Access Audit Site Report

Huntsville State Park

Accessibility Evaluation

Inspection Date: 06/14/2021

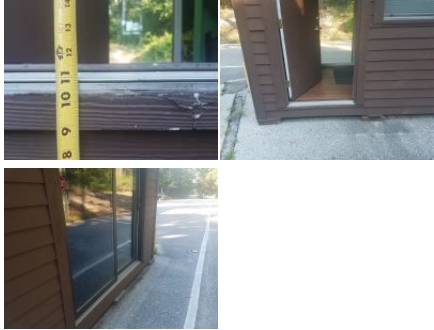
| Finding Number | Area Description | Lat/Long | Finding | As Built | Recommendation | Citation | Photos | Figure |
|----------------|------------------------------------|--------------------------------|---|--|---|--|---|---|
| 12 | Headquarters Area: Headquarters | [30.6284096 , -95.525943 6] | The transaction counter is too high. A portion of the counter surface that is 36 inches long minimum and 36 inches high maximum above the finish floor shall be provided. Knee and toe space must be provided for a forward approach. A 30 inch by 48 inch clear floor space on an accessible route must be provided for either a forward or parallel approach. | Both transaction counters exceed 36" height maximum (43.25" aff) | Lower 36" wide segment of service counter to max 36" aff, in the alternative, train staff to come out from around the counter to provide customer service | 2015 ABAAS Section: 904.4.2, 904.4.1 2012 TAS Section: 904.4.1, 904.4.2 2010 ADAS Section: 904.4.2, 904.4.1 |  |  |

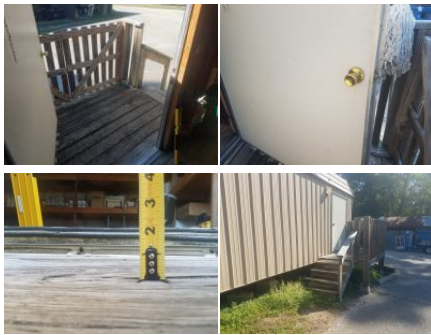
| Finding Number | Area Description | Lat/Long | Finding | As Built | Recommendation | Citation | Photos | Figure |
|----------------|---------------------------------|--------------------------|--|--|--|---|---|---|
| 73 | Employee Spaces: Maintenance | [30.62162, -95.532345 6] | There are no accessible parking stalls. Each lot where parking is provided for the public as clients, guests or employees, shall provide accessible parking and shall be located on the shortest accessible route of travel from adjacent parking to an accessible entrance. There are a total of 6 parking stalls in the parking lot that could be reasonably associated with this facility. There should be a minimum of 1 accessible stalls with a minimum of 1 being designed as van accessible. | Lacks accessible parking stalls (6 standard, 0 accessible) | Create one or more 8' accessible parking stalls, with one 5' adjacent access aisle, with proper signage and striping based on the total number of stalls | 2015 ABAAS Section: F208.2 2012 TAS Section: 208.2 2010 ADAS Section: 208.2 |  |  |

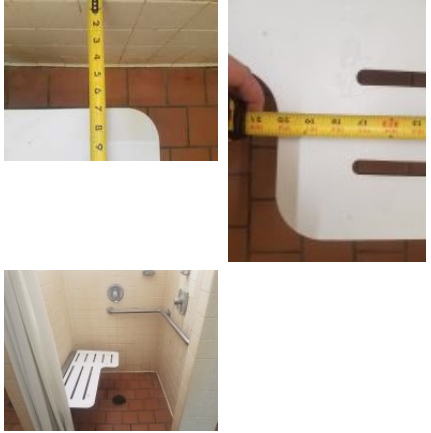
| Finding Number | Area Description | Lat/Long | Finding | As Built | Recommendation | Citation | Photos | Figure |
|----------------|--|----------------------------|--|---|---|---|--------|--------|
| 175 | Coloneh Camping Area: Coloneh Trailhead Area Restrooms | [30.6170429 , -95.525517] | The toilet paper is not installed within the compliant range in front of the toilet. Toilet paper dispensers shall be 7 inches minimum and 9 inches maximum in front of the water closet measured to the centerline of the dispenser. The outlet of the dispenser shall be 15 inches minimum and 48 inches maximum above the finish floor and shall not be located behind grab bars. Dispensers shall not be of a type that controls delivery or that does not allow continuous paper flow. There shall be a clearance of 1 1/2 inches minimum below the grab bar. | Men's restroom - TP too far from toilet - (5") | Remount toilet paper dispenser max 7" to 9" from front of toilet, 15" to 48" aff and min 12" above or 1.5" below grab bar | 2015 ABAAS Section: 604.7 2012 TAS Section: 604.7 2010 ADAS Section: 604.7 | | |

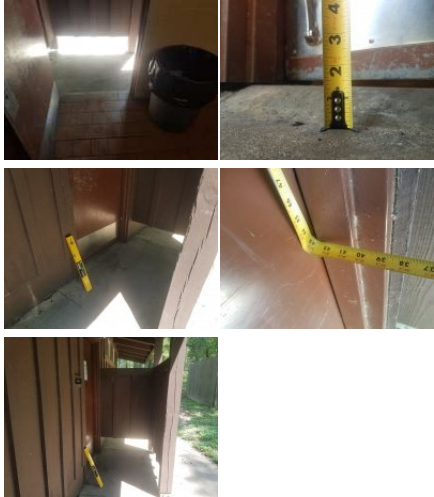
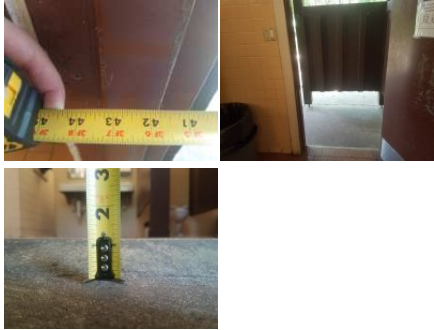
| Finding Number | Area Description | Lat/Long | Finding | As Built | Recommendation | Citation | Photos | Figure |
|----------------|--|-----------------------------|---|--|---|---|---|---|
| 177 | Coloneh Camping Area: Coloneh Trailhead Area Restrooms | [30.6170337 , -95.525525] | The tactile restroom wall sign is missing the International Symbol of Accessibility (ISA). Accessible toilet rooms or bathing rooms shall be identified by the International Symbol of Accessibility (ISA). Wall signs identifying permanent rooms and spaces of a building shall have be horizontal format and the characters raised 1/32 inch minimum and shall be sans serif uppercase characters a minimum of 5/8 inch and a maximum of 2 inches high. Contracted Grade 2 Braille shall be in a horizontal format and shall be placed a minimum of 3/8 inch and a maximum of 1/2 inch directly below the tactile characters; flush left or centered. Signs with raised characters or Braille shall be located 48 inches minimum above the finish floor or ground surface, measured from the baseline of the lowest tactile character and 60 inches maximum above the finish floor or ground surface, measured from the baseline of the highest tactile character. | Women's restroom - Lacks signage with the International Symbol of Accessibility (ISA) | Acquire and mount signage, including access symbol Acquire and mount signage, including Braille and access symbol mounted on wall, latch side of door, 48" to baseline of lowest character and 60" to baseline of highest character | 2015 ABAAS Section: F216.8 2012 TAS Section: 216.8 2010 ADAS Section: 216.8 |  |  |

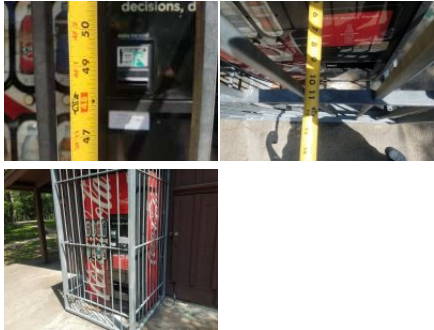
| Finding Number | Area Description | Lat/Long | Finding | As Built | Recommendation | Citation | Photos | Figure |
|----------------|--|-----------------------------|---|--|--|---|---|---|
| 180 | Coloneh Camping Area: Coloneh Trailhead Area Restrooms | [30.6170337 , -95.525517] | There are not enough accessible toilet compartments. The room contains several toilet compartments. A minimum of 1 must be wheelchair accessible . | Women's restroom - Lacks toilet stall with required dimensions to be wheelchair accessible (ambulatory only) | Create a wheelchair accessible stall with grab bars and fixtures mounted in correct locations and at correct heights | 2015 ABAAS Section: F213.3.1 2012 TAS Section: 213.3.1 2010 ADAS Section: 213.3.1 |  | |

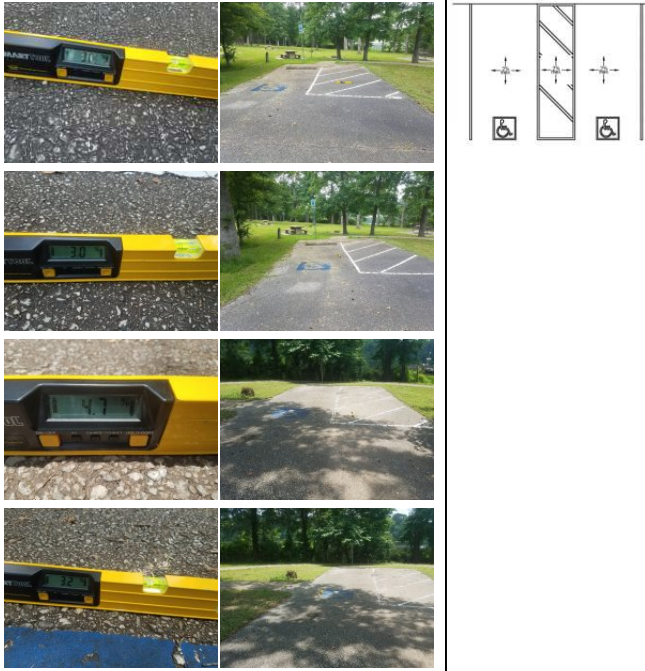
| Finding Number | Area Description | Lat/Long | Finding | As Built | Recommendation | Citation | Photos | Figure |
|----------------|---|-----------------------------|--|---|--|---|--|---|
| 260 | Coloneh Camping Area: Coloneh Campsites | [30.6168294 , -95.524539 3] | The handrail does not extend past the ramp. Handrails must be between 34 inches and 38 inches above the ramp surface, must extend beyond the top and bottom of the ramp 12 inches horizontally, be parallel to the floor or ground surface and be in the same direction as the ramp runs. The 12 inches must be level and does not include the radius at the top of round handrails. Extensions shall return to a wall, guard, or the landing surface, or shall be continuous to the handrail of an adjacent ramp run. | The handrail extension does not terminate properly | Provide handrail extensions that project 12" onto the ramp landing | 2015 ABAAS Section: 505.10.1 2012 TAS Section: 505.10.1 2010 ADAS Section: 505.10.1 |  | |

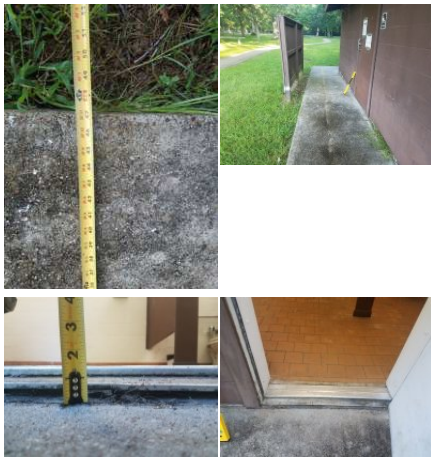
| Finding Number | Area Description | Lat/Long | Finding | As Built | Recommendation | Citation | Photos | Figure |
|----------------|-------------------------------|--------------------------------------|---|---|---|--|---|---|
| 325 | Day Use Area: Picnic Areas | [30.6142666 , -95.534345 3] | The accessible route of travel on the accessible route contains cross slopes greater than 2%. Cross slopes shall not exceed one unit vertical in 48 units horizontal (2-percent slope). | Cross slope of 2.7% near lodge parking | Correct or repair cross slope along AR to max 2.08% | 2015 ABAAS Section: 403.3 2012 TAS Section: 403.3 2010 ADAS Section: 403.3 |  |  |

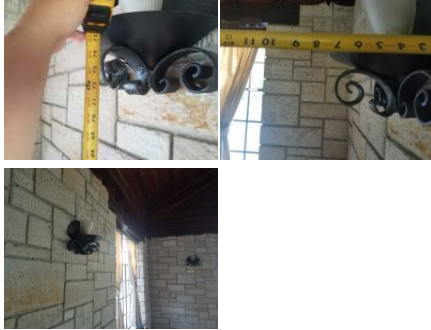
| Finding Number | Area Description | Lat/Long | Finding | As Built | Recommendation | Citation | Photos | Figure |
|----------------|---------------------|-----------------------------|---|---|---|--|--|--|
| 377 | Day Use Area: Lodge | [30.6132873 , -95.533759 4] | The hand dryer projects more than 4 inches into the circulation path. Wall-mounted objects that have leading edges between 27 inches and 80 inches from the floor must not project more than 4 inches into the circulation path. Protruding objects that extend to the floor or within 27 inches of the floor are cane detectable and are therefore not hazardous. Where it is necessary or desirable to have objects protrude from the wall, a manner of cane detection must be provided. | Men's restroom - Hand dryer protrudes 8" | Relocate protruding objects or place cane detectable warning or bollard at foot of item | 2015 ABAAS Section: 307.2 2012 TAS Section: 307.2 2010 ADAS Section: 307.2 |  |  |

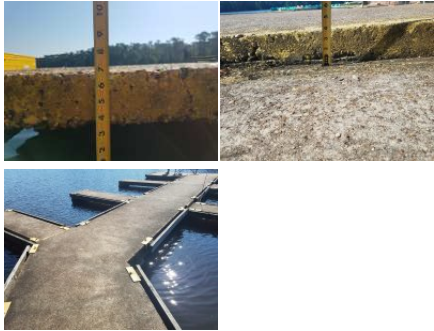
| Finding Number | Area Description | Lat/Long | Finding | As Built | Recommendation | Citation | Photos | Figure |
|----------------|---|--------------------------------------|---|---|--|--|---|---|
| 457 | Day Use Area: Day Use Area Park Amenities | [30.6135897 , -95.533414 7] | There is no accessible route to the play area. Accessible routes serving play areas shall comply with Chapter 4 and 1008.2 and shall be permitted to use the exceptions in 1008.2.1 through 1008.2.3. Where accessible routes serve ground level play components, the vertical clearance shall be 80 inches high (2030 mm) minimum. | Lacks accessible route to play area | Create an AR to the play area within the site | 2015 ABAAS Section: F206.2.2 2012 TAS Section: 1008.2 2010 ADAS Section: 206.2.2 |  |  |

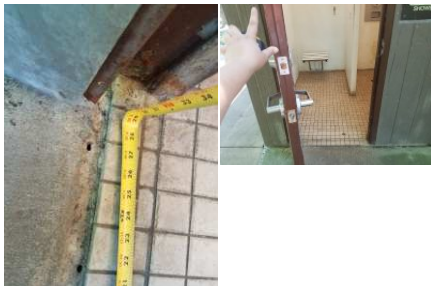
| Finding Number | Area Description | Lat/Long | Finding | As Built | Recommendation | Citation | Photos | Figure |
|----------------|---|--------------------------------------|--|---|--|--|--|---|
| 493 | Shelter Sites: Shelter Sites Restroom | [30.6168883 , -95.536098 3] | The required 56 inches by 60 inches clear floor space for the water closet has been obstructed. The clear floor space around the water closet shall be 60 inches minimum measured perpendicular from the side wall and 56 inches minimum measured perpendicular from the rear wall. | Women's restroom - garbage can in toilet clearance | Relocate garbage can to provide required 60" clearance around toilet | 2015 ABAAS Section: 604.3. 2012 TAS Section: 604.3.1 2010 ADAS Section: 604.3.1 |  | |

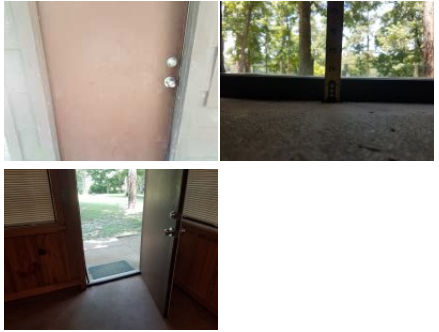
| Finding Number | Area Description | Lat/Long | Finding | As Built | Recommendation | Citation | Photos | Figure |
|----------------|--|--------------------------------------|--|--|---|--|---|---|
| 531 | Shelter Sites: Shelter Campsites | [30.6175138 , -95.536489 9] | 36 inches (915 mm) on all usable sides of the table measured from the back edge of the benches | Site 22 - Lacks 36" clear ground space around picnic table | Provide required 36" clear ground space around all usable portions of the table as a smart practice | 2015 ABAAS Section: 1011.2.1 |  | |

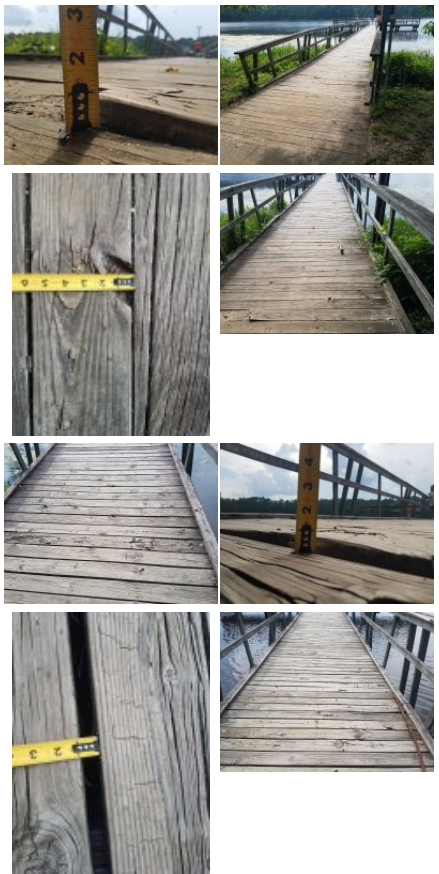
| Finding Number | Area Description | Lat/Long | Finding | As Built | Recommendation | Citation | Photos | Figure |
|----------------|--|--------------------------------------|---|--|---|--|--|--------|
| 597 | Prairie Branch Camping Area: Prairie Branch Restrooms | [30.6197898 , -95.534655 2] | The stall door fails to comply with all of the door requirements. The stall door must be a minimum of 32" wide and have compliant hardware on both sides. The stall door must be self-closing. | Men's restroom - Lacks self-closing door (does not fully close) | Adjust stall door to be self-closing | 2015 ABAAS Section: 404.2.3, 404.2.7, 604.8.2.2 2012 TAS Section: 404.2.3, 404.2.7, 604.8.2.2 2010 ADAS Section: 404.2.3, 404.2.7, 604.8.2.2 |  | |

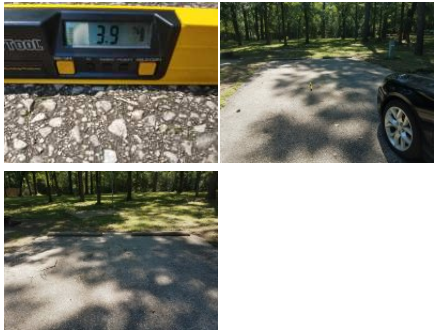
| Finding Number | Area Description | Lat/Long | Finding | As Built | Recommendation | Citation | Photos | Figure |
|----------------|---|-----------------------------|--|--|---|--|--|--|
| 622 | Prairie Branch Camping Area: Parking - Fishing At Prairie Branch Loop | [30.6189703 , -95.536272 6] | The cross slopes (narrow dimension) and/or running slopes (long dimension) of the access aisle exceeds 2%. The running slope and the cross slope in an accessible parking stall and the access aisle must not exceed 2%. | Slopes of 3.2% in access aisle and 2.3% in right stall | Repair or correct slope of parking space and access aisle to max 2.08% in any direction | 2015 ABAAS Section: 502.4 2012 TAS Section: 502.4 2010 ADAS Section: 502.4 |  |  |
